**THE GILINSKY/BRADFORD
DISSENTING OPINION ON
NRC'S FAILURE TO REVIEW
THE APPEAL BOARD'S
APPROVAL OF DIABLO
CANYON'S SEISMIC DESIGN**

In the Matter of)
)
PACIFIC GAS & ELECTRIC COMPANY)
)
(Diablo Canyon Nuclear Power)
Plant, Units 1 and 2))
)
_____)

Docket Nos. 50-275 OL
50-323 OL

OPINION OF COMMISSIONERS GILINSKY AND BRADFORD ON COMMISSION
REVIEW OF ALAB-644 (DIABLO CANYON SEISMIC PROCEEDING)

DIABLO CANYON CONTAINMENT STRUCTURE
 COMPARISON OF VARIOUS ELASTIC RESPONSE SPECTRA

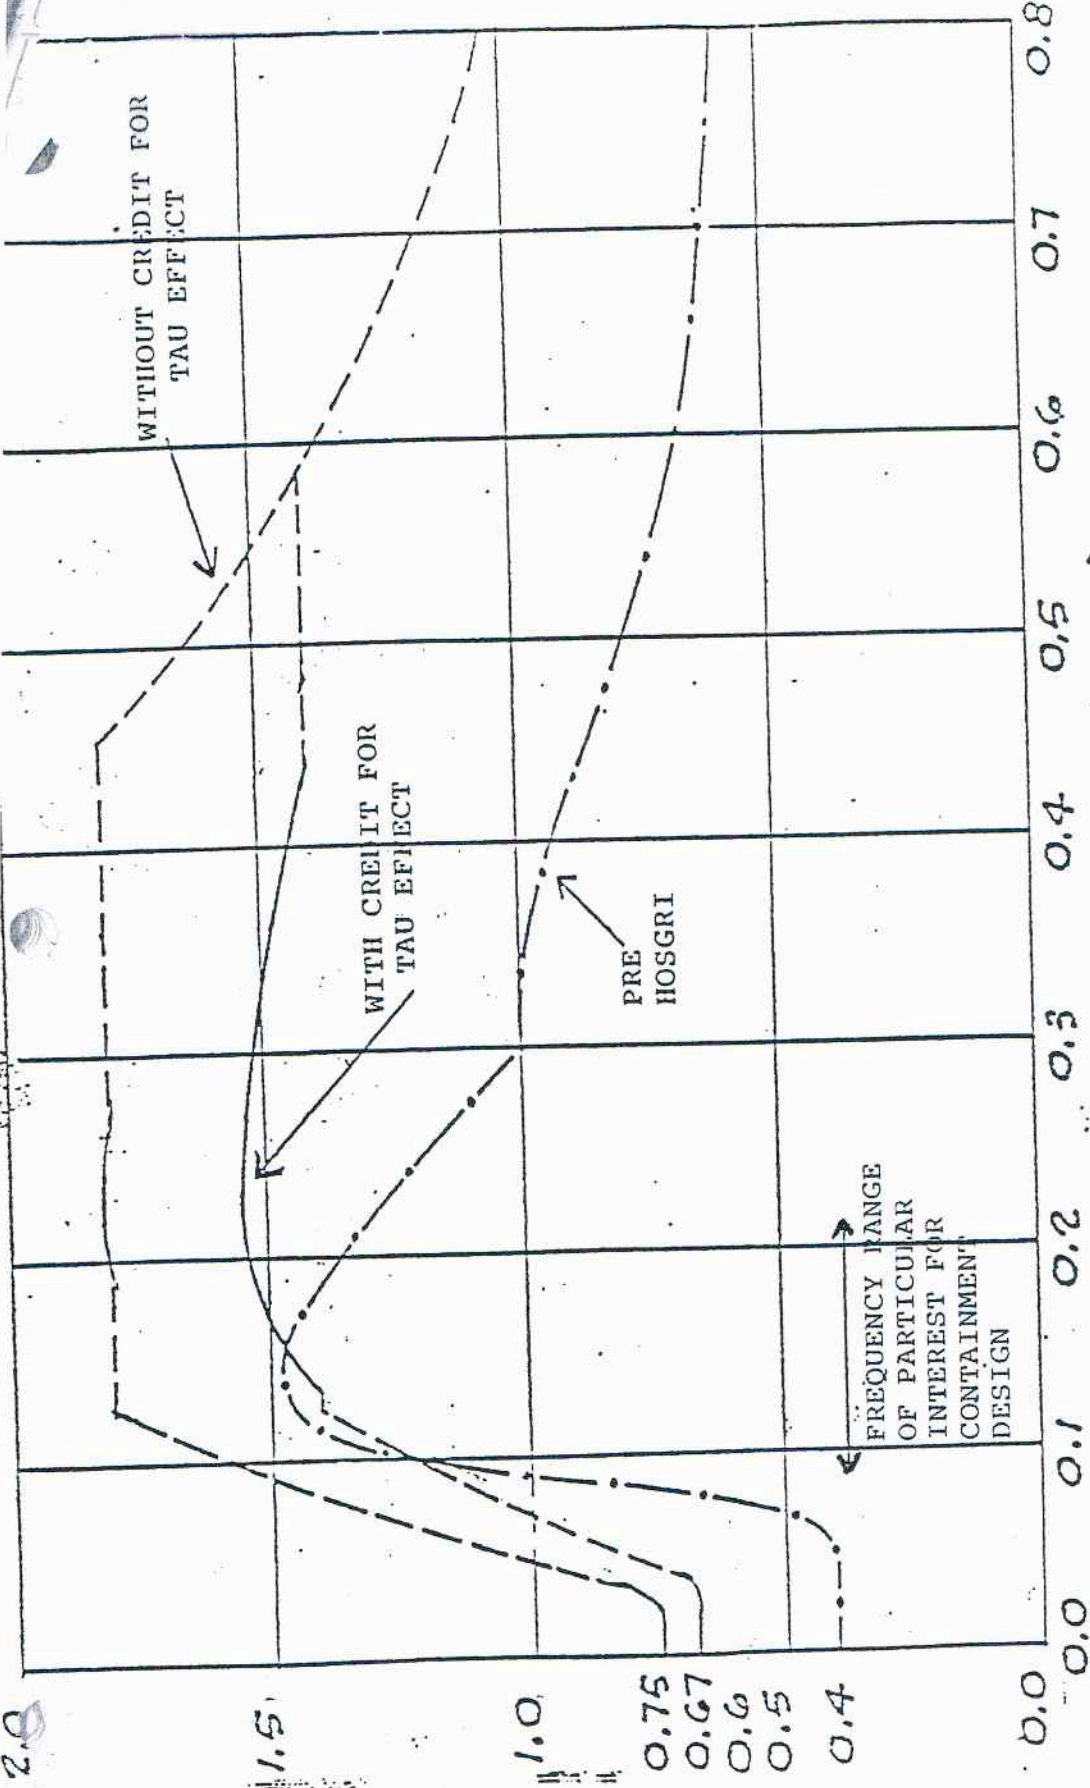
With the changes and adjustments permitted by the Board it turns out that the post-Hosgri seismic response spectrum does not in all respects represent a more severe seismic standard than the one used before the discovery of the Hosgri fault. As the accompanying diagram illustrates, in the frequency range between 5 and 10 hertz (cycles per second), a range of particular interest in the analysis of the containment building surrounding the reactor, the two response spectra are quite close.¹⁰ For part of this range, in fact, the old spectrum shows a higher response. In other words, for that part of the range the original design conditions were more demanding than the new ones imposed after the discovery of the Hosgri fault. This new

spectrum is the basis of the engineering reanalysis and ultimately determined the extent to which the containment was to be modified. Not surprisingly, in view of the above, only minor changes were required in this area.
